Subject: Limerick Generating Station, Unit 2
Request Relief for First Ten-Year Interval Inservice
Inspection Program Regarding System Pressure Testing

Attached for review and approval is Revision 1 to Relief Request No. RR-13 for the Limerick Generating Station (LGS), Unit 2, First Ten-Year Interval Inservice Inspection (ISI) Program. Revision 1 to Relief Request No. RR-13 requests relief from the requirements of Section XI of the American Society of Mechanical Engineers (ASME) Boiler and Pressure Vessel (B&PV) Code, 1986 Edition, regarding system pressure tests for various Class 2 and 3 pressure retaining components, which includes piping, pumps, and valves. This Relief Request was originally submitted (i.e., Revision 0) for NRC review and approval by letter dated March 12, 1993.

**RELIEF REQUEST NO. RR-13
Revision 1**

Figure RR-13-1.7a
(Ref P&ID: ISI-M-57, Sht 4)

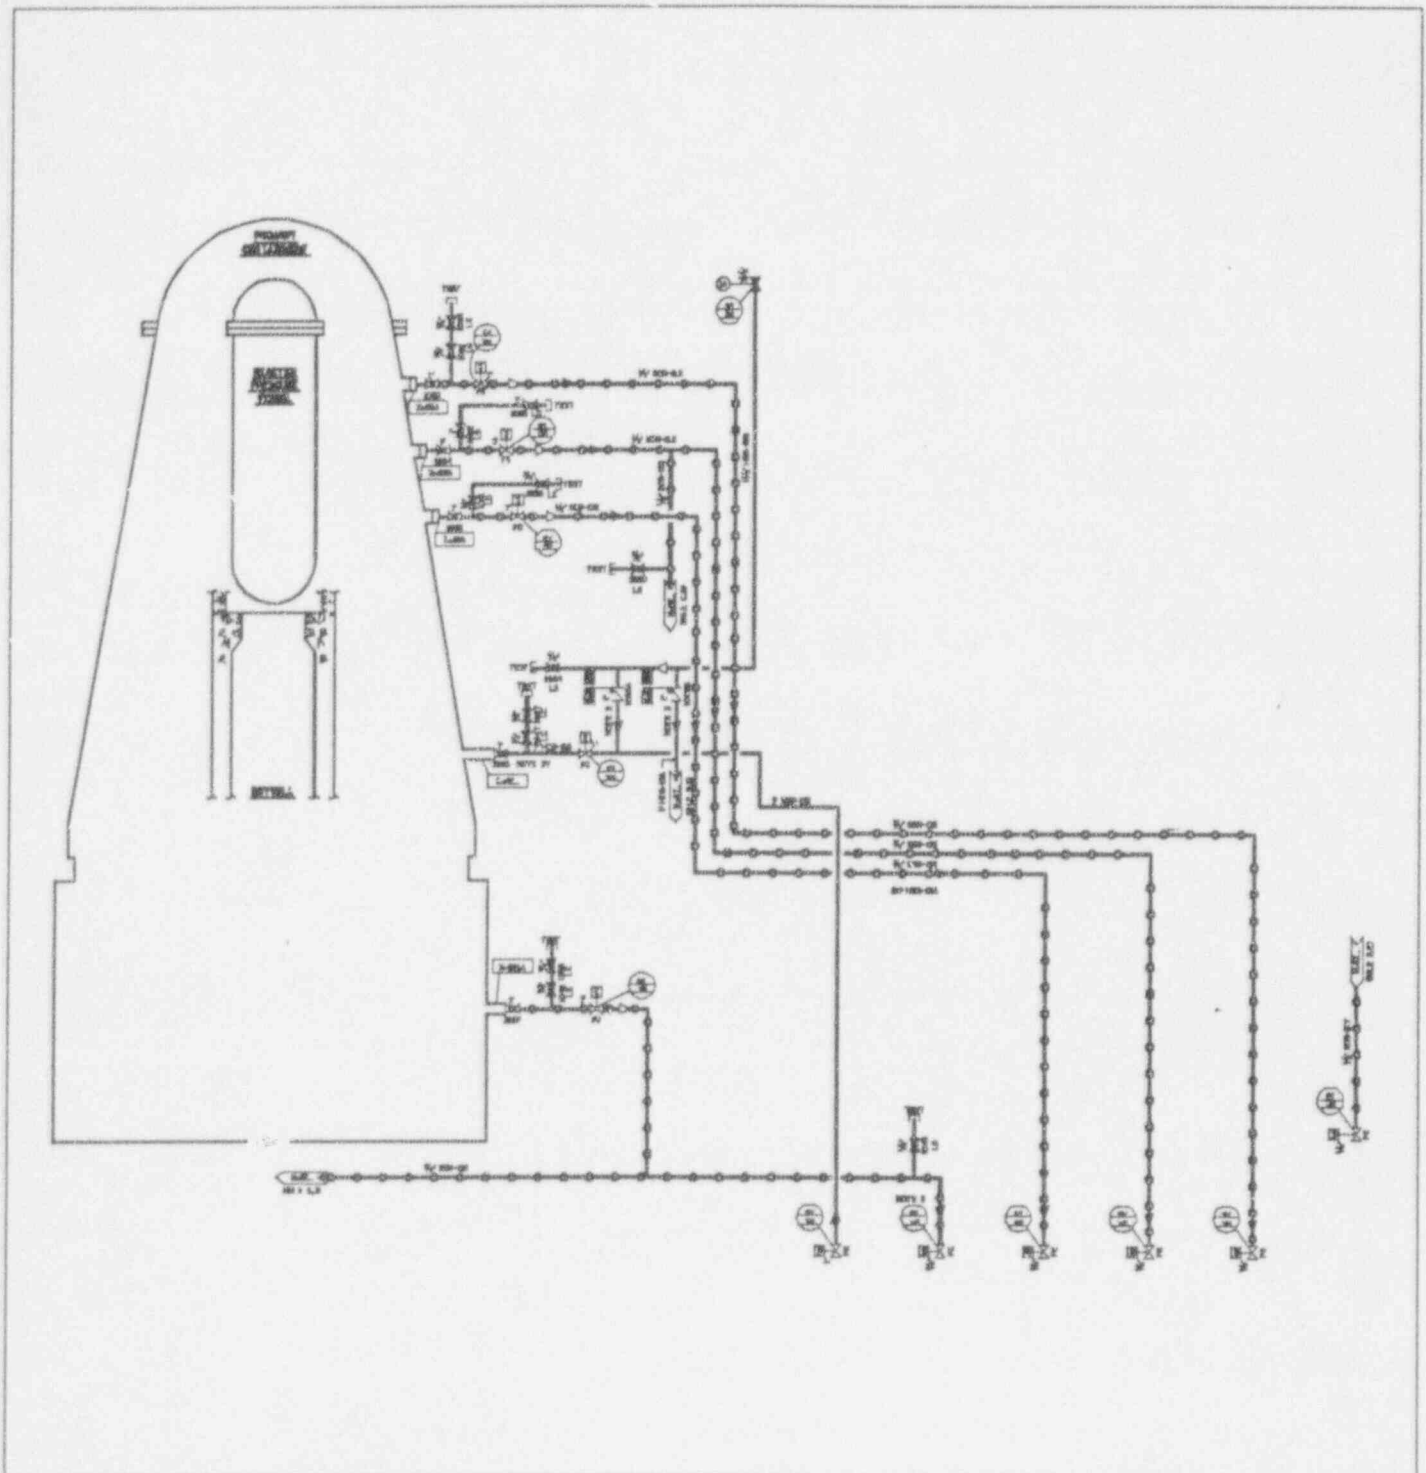
Class 2 Containment Atmospheric Control piping as illustrated in figures RR-13-1.7a & b.

During normal plant operation, this piping is either isolated or less than 1 psig (normal containment pressure). The pressurizing fluid is essentially nitrogen gas. A VT-2 inspection looking for a nitrogen gas leak with less than 1 psig driving pressure would be inconclusive.

Appendix J LLRTs are performed once per Refuel Outage. During LLRTs, the subject piping is pressurized to 44 psig, a substantially higher pressure than that developed during a system functional test. As such, the LLRT offers the following advantages over system pressure tests:

- 1) LLRTs are performed more frequently than periodic system functional tests.
- 2) LLRTs have the ability to quantify leakage which is not feasible with VT-2 inspection on this essentially gas-filled piping.
- 3) LLRTs conservatively include through valve leakage which would not be identified in a VT-2 inspection.

10CFR50 Appendix J Local Leak Rate Testing (LLRT) provides assurance of component integrity.
